CITY COUNCIL Q&A FOLLOW-UP
BRADDOCK ROAD CORRIDOR IMPROVEMENTS PROJECT

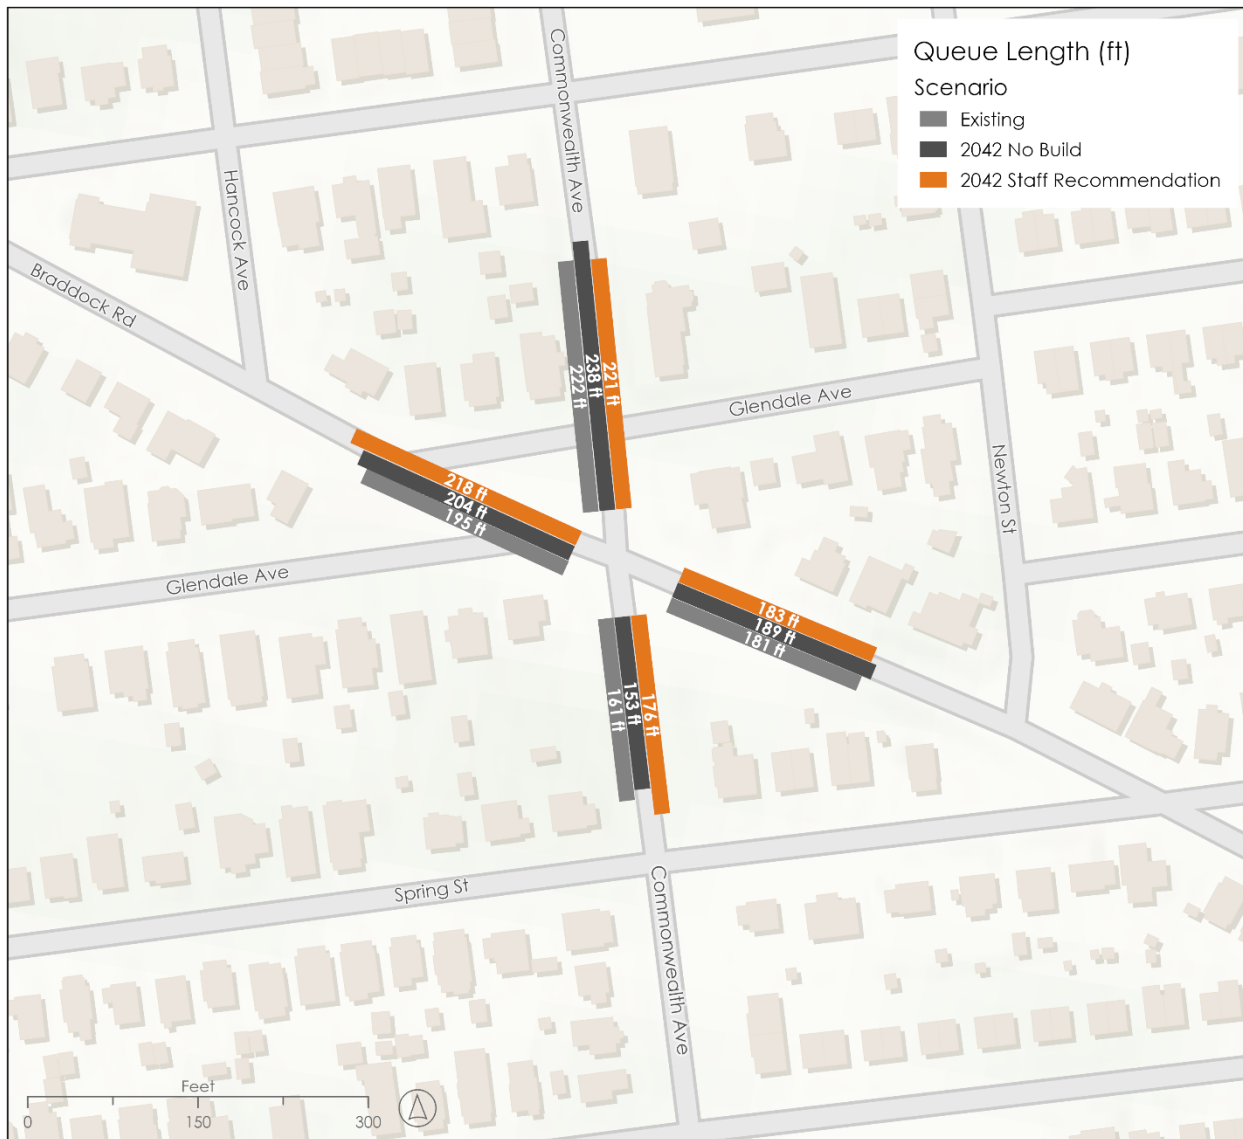
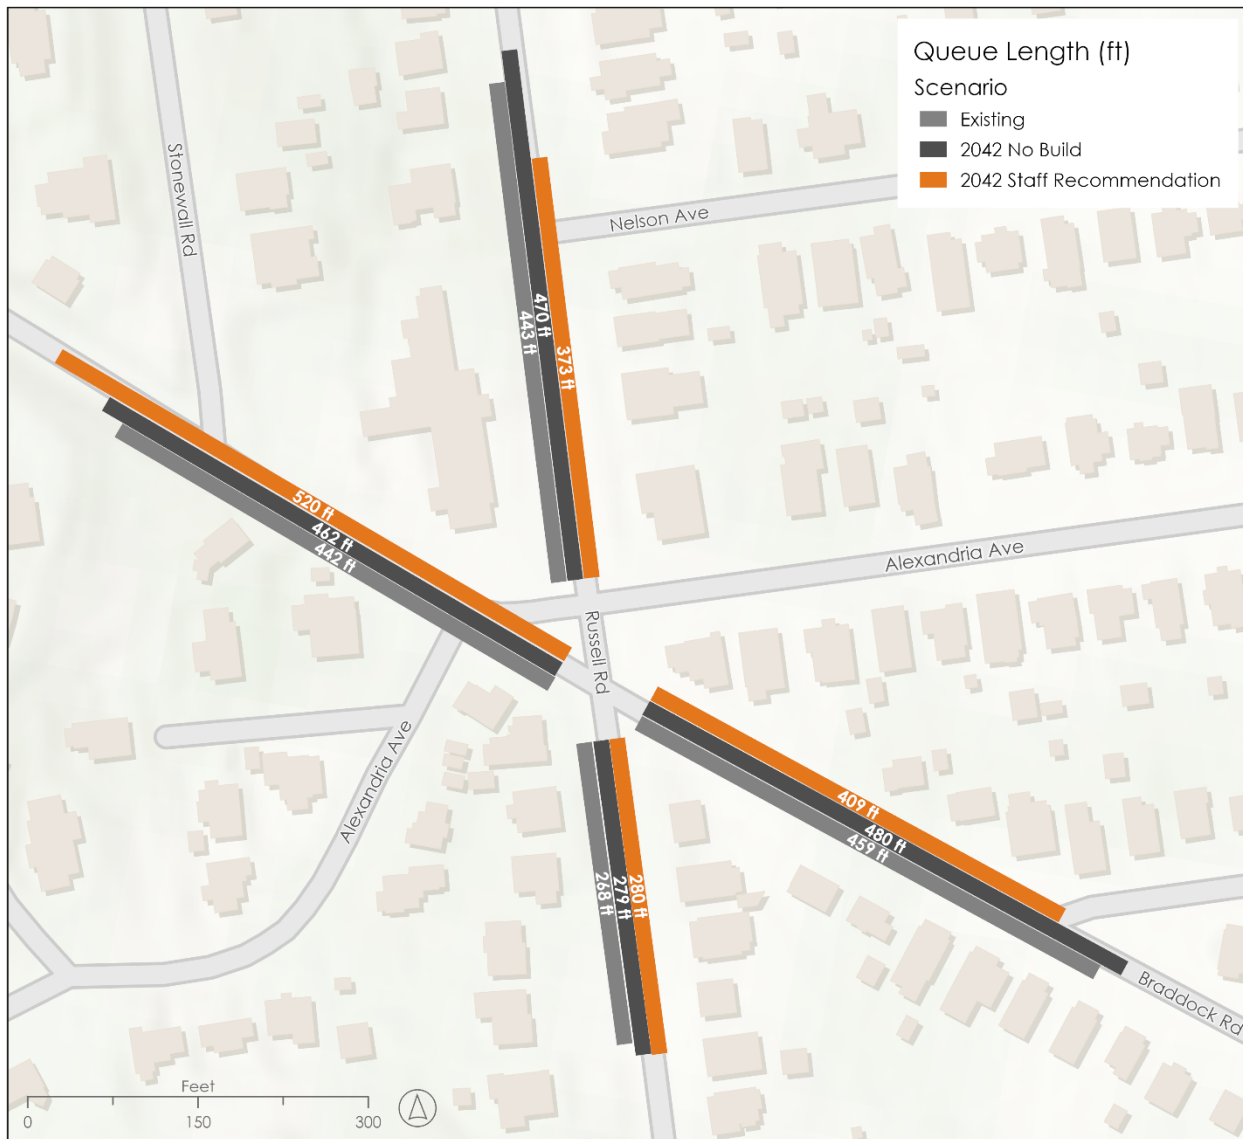
HOW CAN TRAFFIC OPERATIONS REMAIN SIMILAR IF DEDICATED TURN LANES ARE REMOVED OR CONSOLIDATED?

The Highway Capacity Manual states that left-turn lanes should be considered where left-turn volumes exceed 100 vehicles per hour. All locations where left turn lanes are proposed to be consolidated have left-turn volumes less than 100 during the peak hour, and thus, left turn lanes are not recommended. The project team performed a traffic analysis to assess the impact of consolidating the left turn lanes with the through/right lanes and found that overall traffic delay would remain similar to today. (Tables displaying analyses on following pages.)

Figure 1. Braddock Road/Russell Road | Eastbound

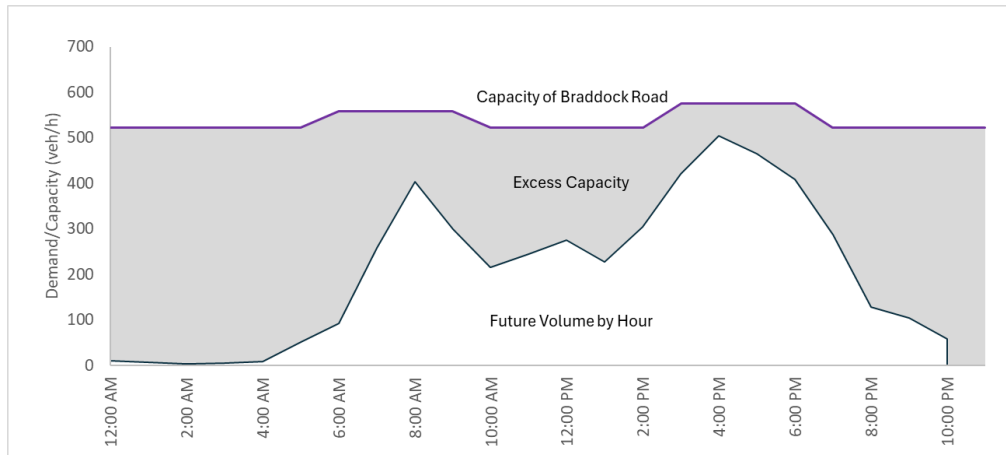
THE PROJECT TEAM ANALYZED THE PEAK HOUR CONDITIONS. HOW WOULD THE CORRIDOR PERFORM THE REST OF THE DAY?

The project team completed a 24-hour analysis to understand what the corridor’s volume-to-capacity (V/C) ratio is throughout the day. That analysis found that during the busiest time of day, Braddock Road operates between 42-84% of its capacity and will continue to operate under capacity with the proposed changes. The intersections operate well under capacity for the other hours during the day.

The charts below demonstrate the amount of traffic volume relative to capacity of Braddock Road at Russell Road going eastbound and westbound, which is the area with the highest volume during the PM peak.
